# 1419 24TH AVENUE

**Project #:** #3032295-EG, 3035044-LU

**Meeting Type:** Recommendation Packet

# SUMMARY OF GUIDANCE

MASSING

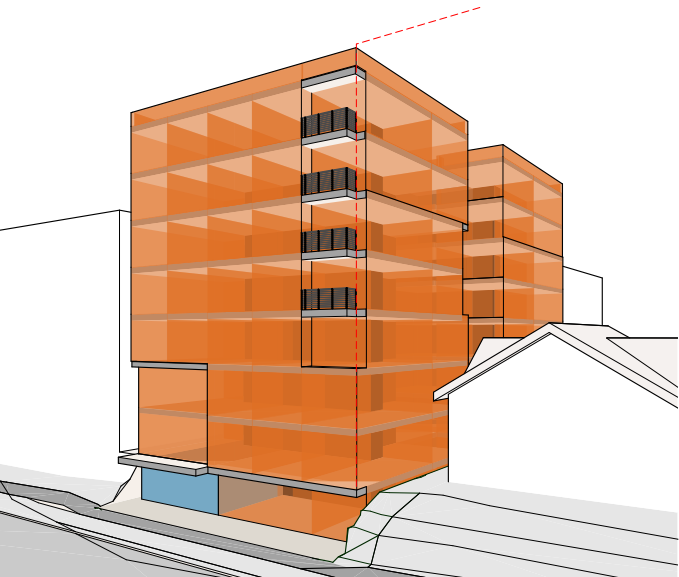
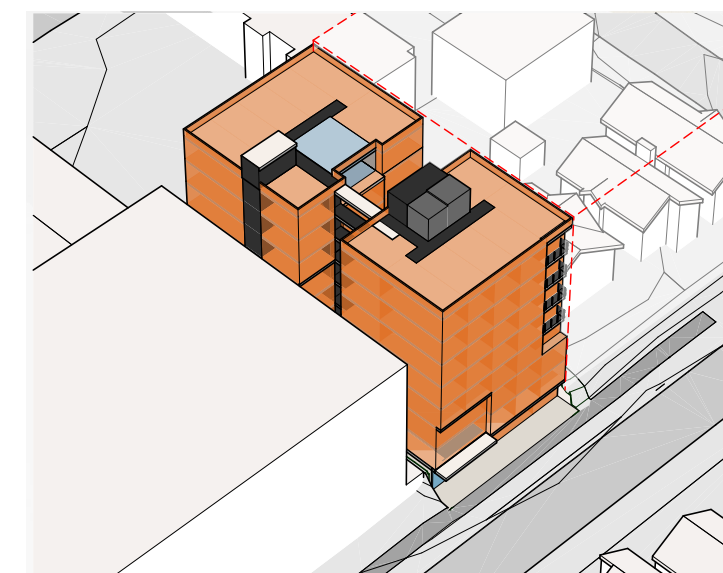
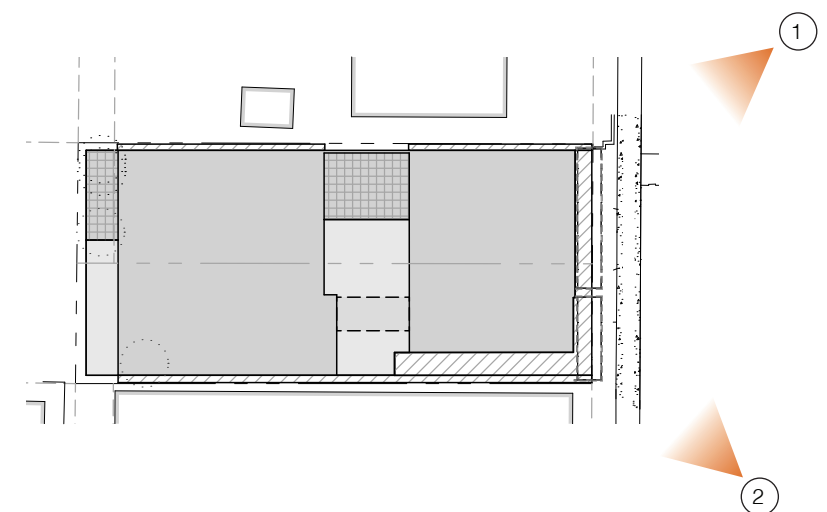
b. The height of the proposal was a cause for concern. They suggested that the applicant step the front volume back on the top story as a way to better fit with the lower scale surrounding the proposal. (DC2-A-2 and DC-1-G)

- The proposal has provided an upper level setback that aligns with the setback along the north side of the structure above the third floor, increased to 4 feet following the MUP Submission. In order to maintain the massing and material clarity, the recessed wall at the north side of the east facade (also previously 3 feet), has been increased to 4 feet to be flush with the upper level setback. This provides the visual continuation of that “plane” in the front facade with the same material cladding. In addition, the awnings have been minimized. In total, the setback is more legible.
- The ground floor wall for the two units has been further updated to provide the code required 10-foot minimum setback at the street-level street-facing facade.
- Stair and Elevator Penthouses are located away from the north property line.

# ARCHITECTURAL CONCEPT

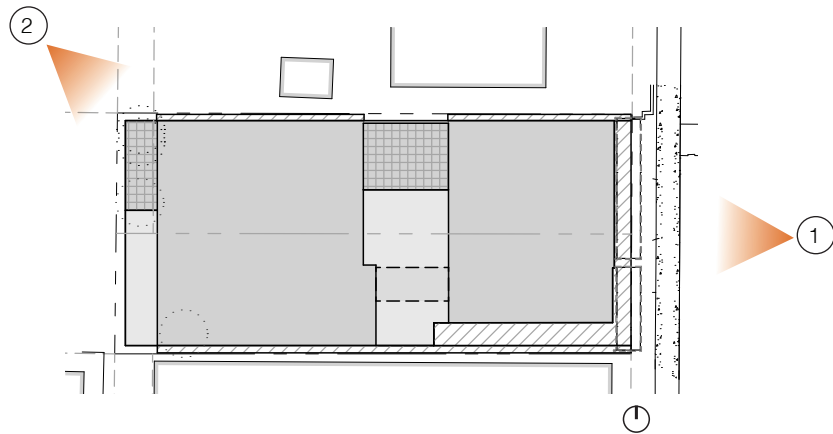
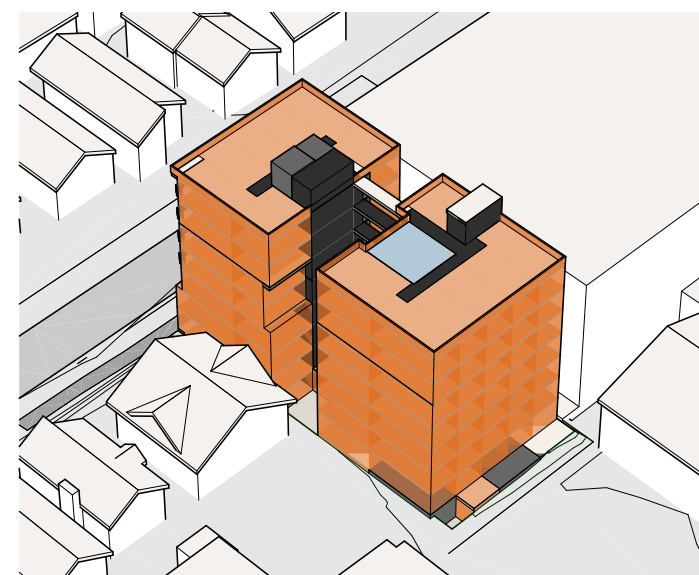
c. The Board expressed enthusiasm for the Passive House goals of the applicant. They suggested that the sustainability features of the building type be visible at recommendation. (CS1 and DC-2-E-1)

- The proposal has maintained its commitment to Passivhaus certification. Since EDG, the project team has engaged multiple consultants engaged in the Passivhaus design process to support the project goals. This process includes an analysis of the project massing, wall, floor and roof assemblies, window design and ventilation strategies. As a result, the massing of the proposal remains relatively simple, deliberate modulation and material variation. Pattern and texture contribute to the facade design, creating a holistic solution on all sides of the proposal.

- Natural wood has been added at the undersides of the canopies at the ground floor and at the eighth floor to create a subtle accent in the areas where they will be easily experienced.

- The design of gangway bridges have evolved since the MUP submission. They will be precast concrete at all floors with glass railings with minimal attachments. An example of the railing is included in the Recommendation packet.

# STREETSCAPE

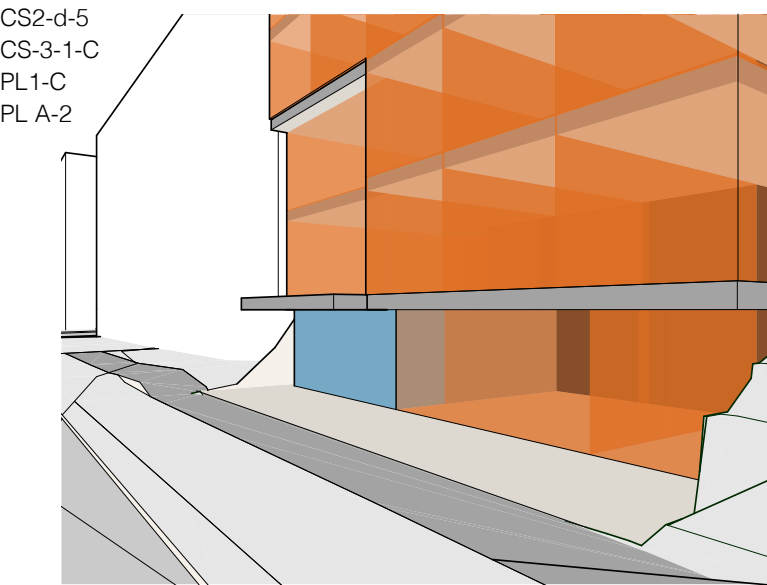
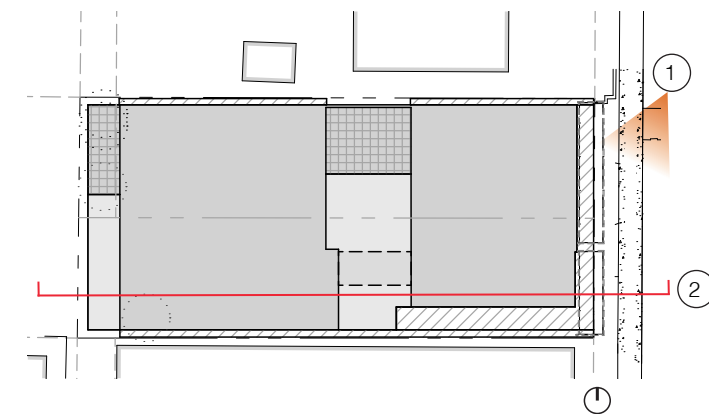
c. Much of the conversation was about the ground floor. Board members expressed a desire to see a commercial use at this space as this would best activate the area. At the very least they requested (CS2-d-5, CS-3-1-C, PL1-C, PL A-2)

i. A taller ground floor on the front of the building

ii. Work to open up the lobby and connect it to the street with glazing and size

iii. A study of live work options on the site

- The ground floor height has been increased by 2 feet, to a clear ceiling height of 10'-9".
- The lobby is treated similar to a storefront and includes taller glass and increased transparency. The second floor is recessed to the same plane as the lobby in order to make it more pronounced at the street. Landscaping is proposed in front of the units to screen the units from the street and building entry.

- The two units facing the street on the first floor adjacent to the lobby now include the taller ceiling as well. These units are proposed to be residential in use, noting that the adjacent properties to the north are all residential in nature. In addition, the commercial presence in the Liberty Bank Building is located at the corner of 24th Avenue and E Union Street with its community room, courtyard and lobby, bike room, parking entry and trash storage room composing the remainder of its facade along 24th Avenue. Acknowledging these adjacent uses results in our proposal that the units at street level remain residential in nature. However, if a commercial use may in fact be desirable in the future, these two units can be converted into one more viable commercial spaces.

COURTYARD/OPEN SPACE

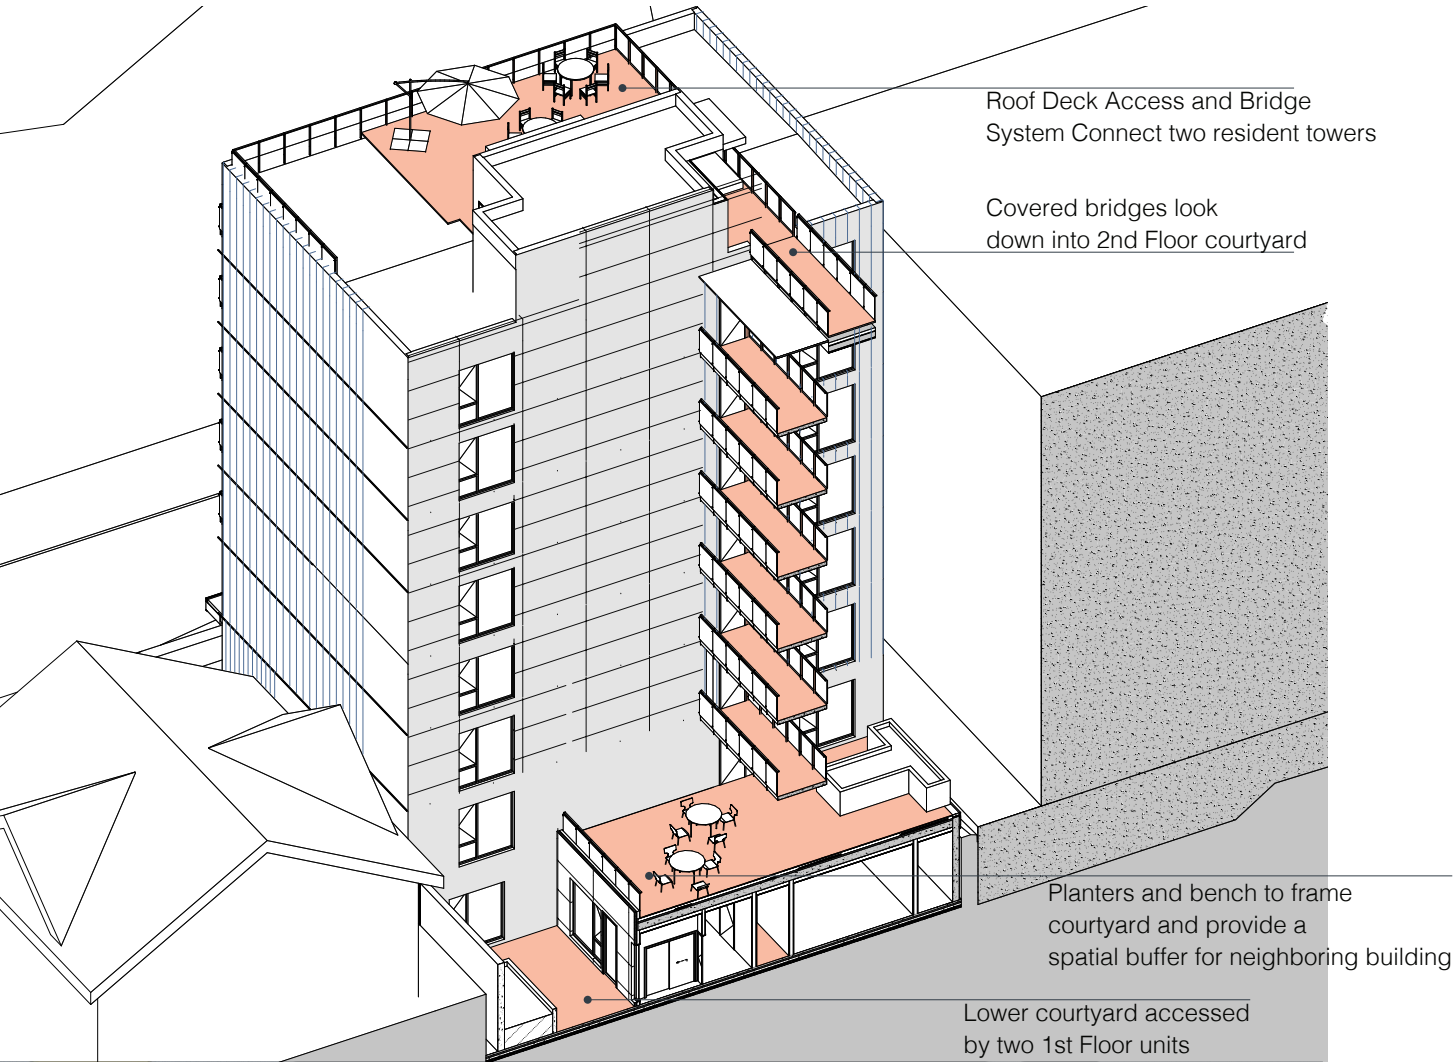
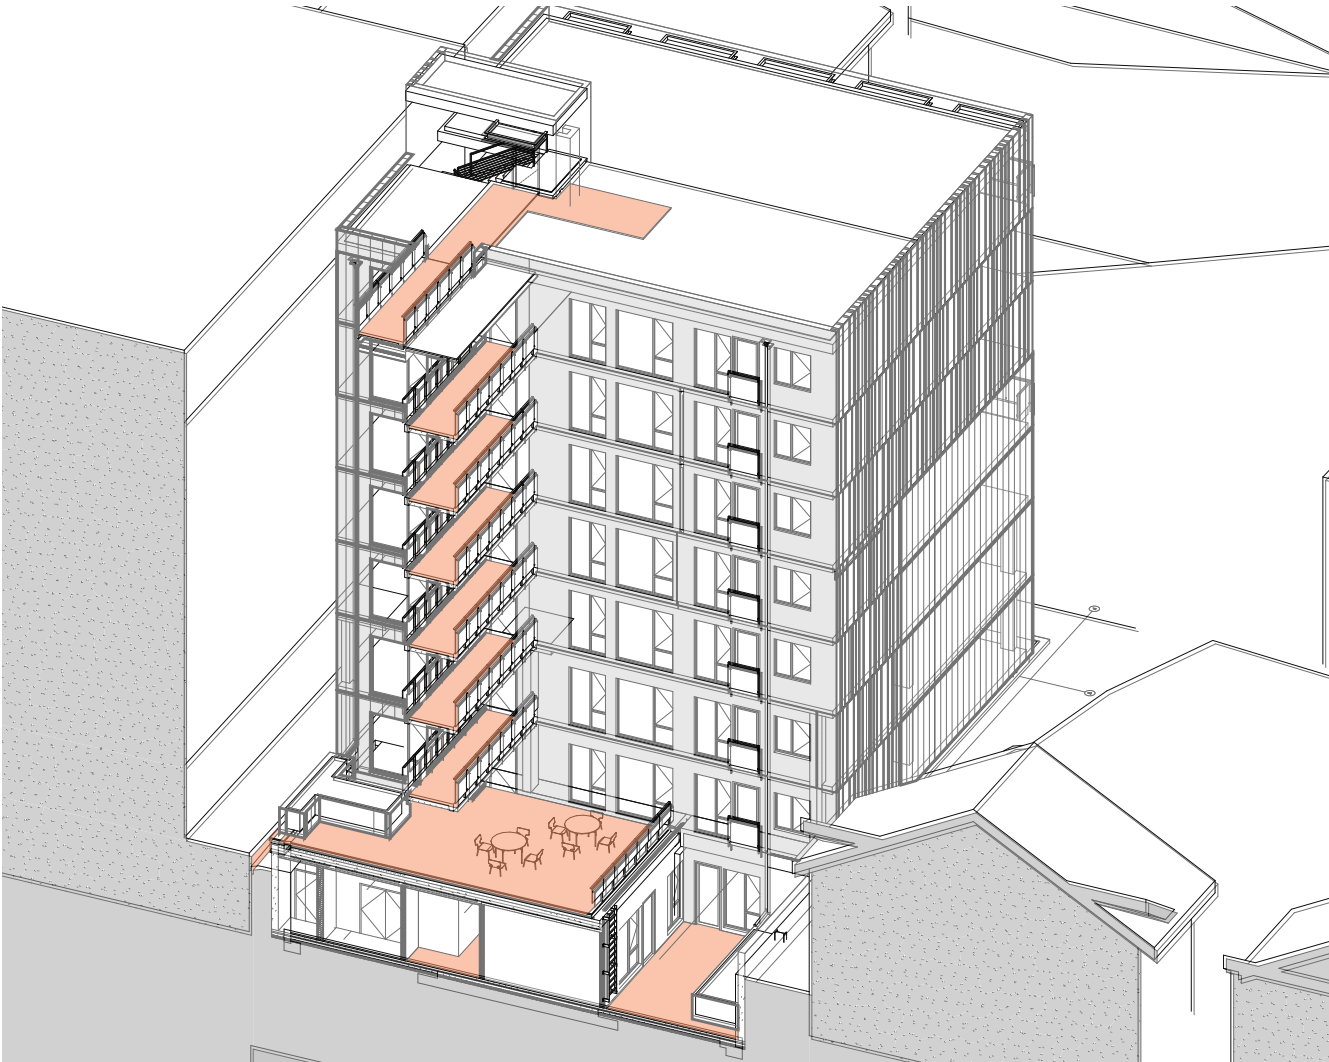
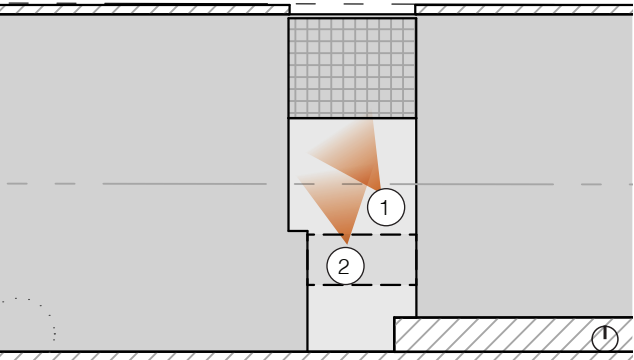
The courtyard is a really critical component of the project, and it is one of your team’s great strengths. Be sure to include many perspectives inside the Courtyard in the Rec proposal.

- The massing of the proposed scheme has been developed. The courtyard is a really critical component of the project, and it is one of your team's great strengths. Be sure to include many perspectives inside the Courtyard in the Rec proposal

1 East Elevation with Facade Modulation Diagrammed

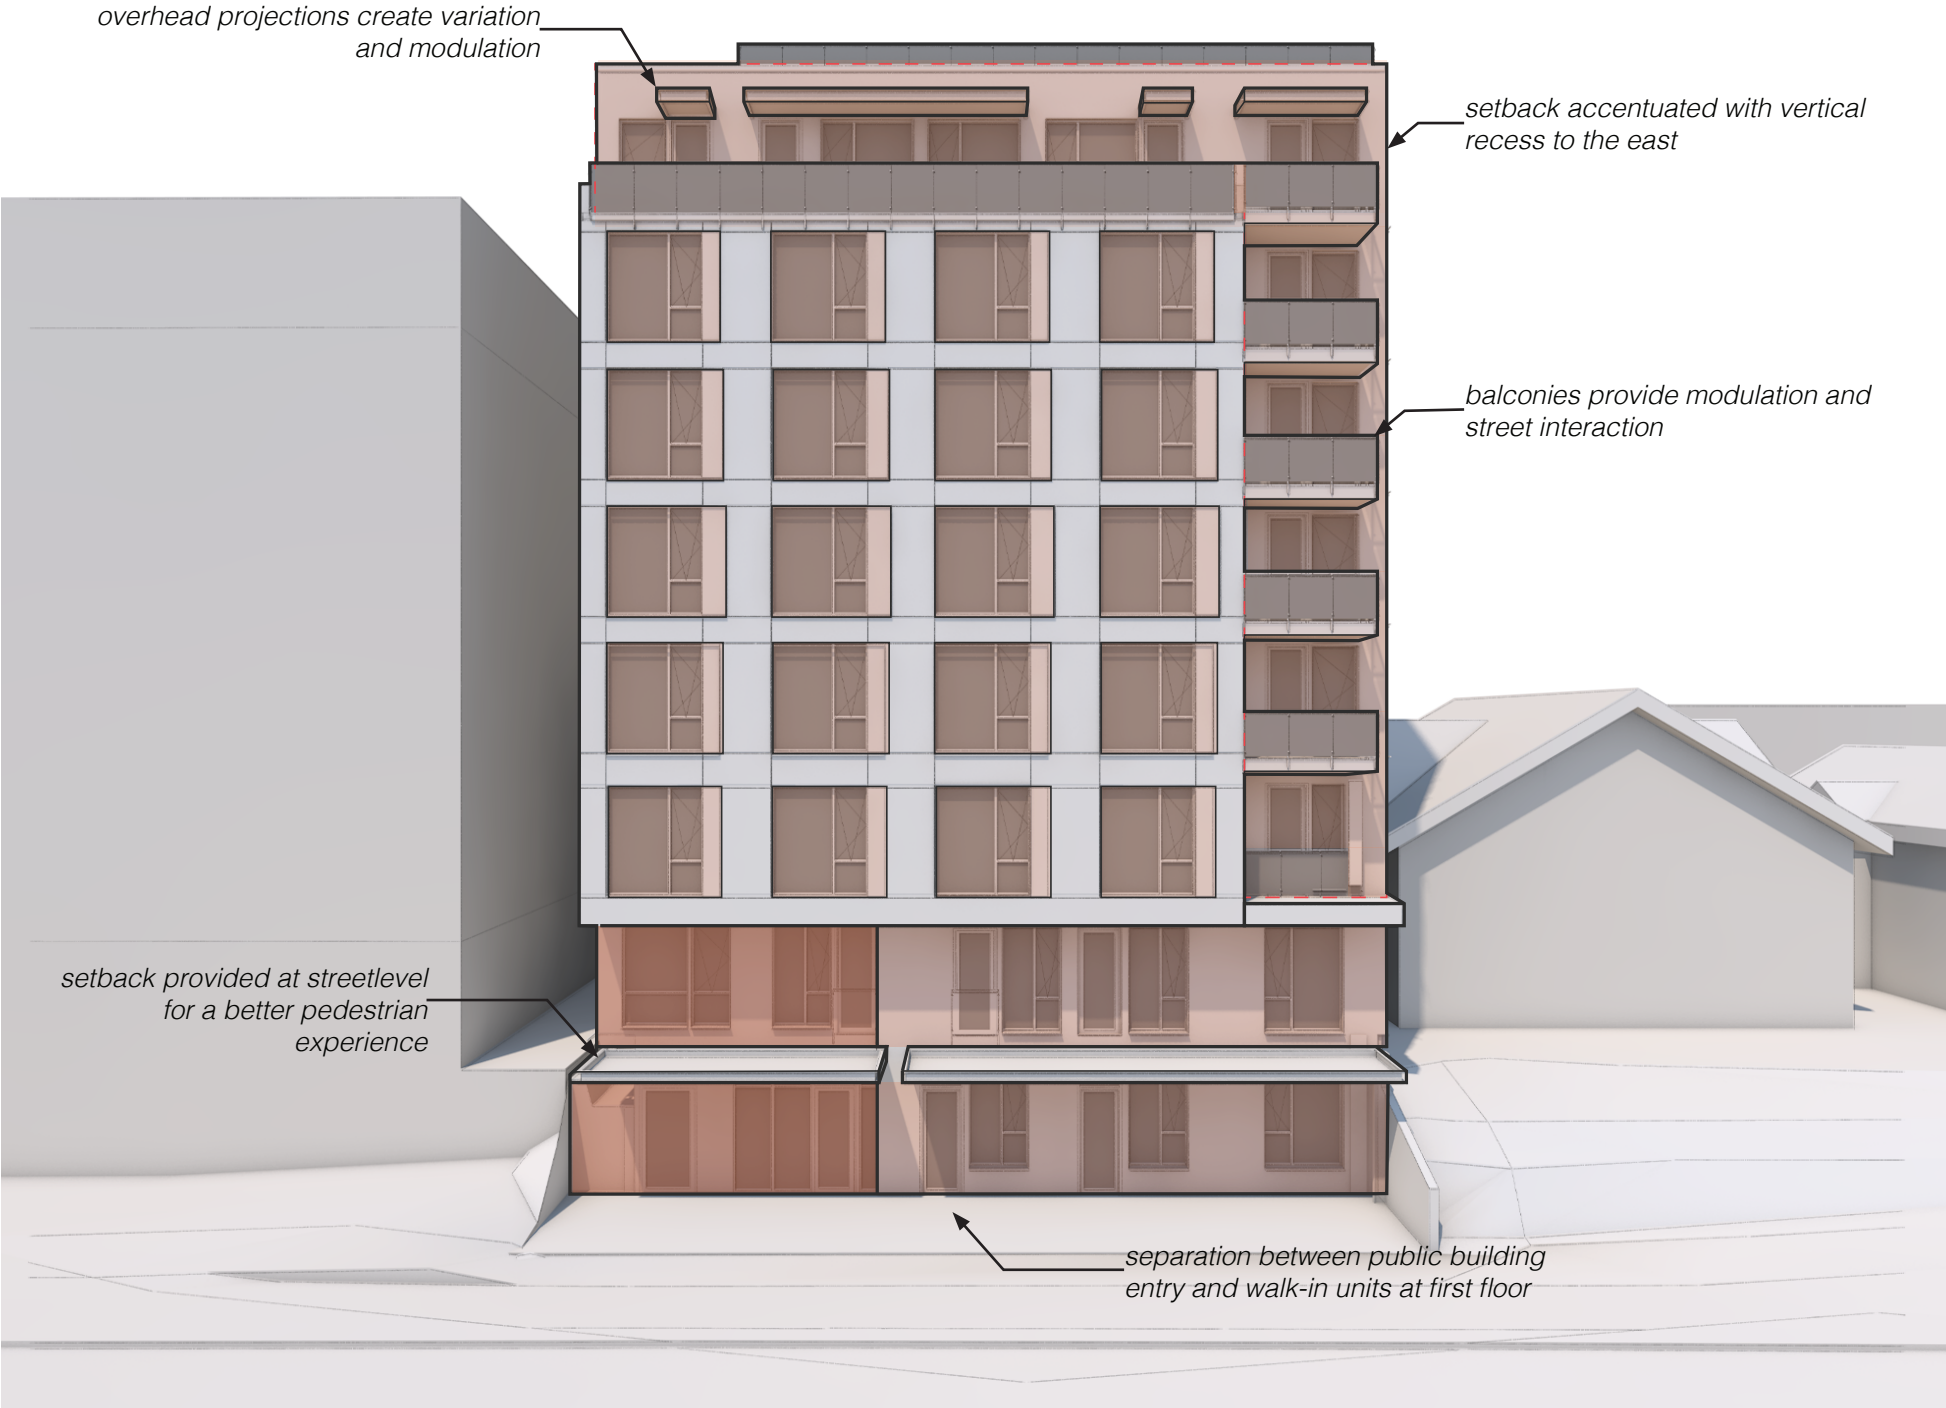
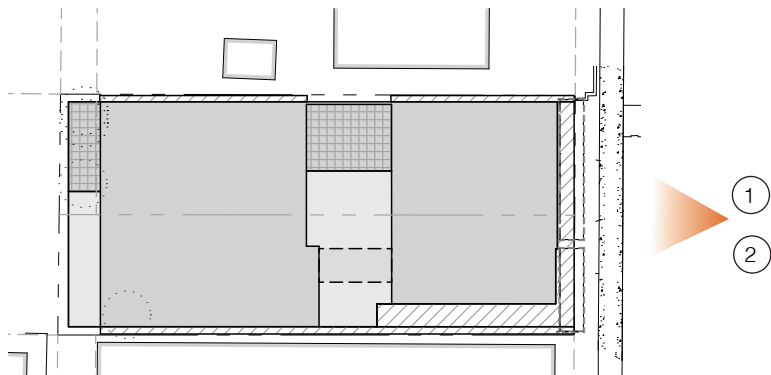
a. The North wall was a point of concern for the Board. They requested that the applicant explore some kind of special treatment here to mitigate its monotony. While they did not wish to explicitly direct the applicant how to mitigate this condition, they suggested it could be tied to the art proposed on site. (DC2-B-2 and DC-2-E-1)

- The proposal treats all facades consistently. Material variation expresses massing elements in the east and west-facing facades. These materials/colors wrap on to the north and south facing facades.
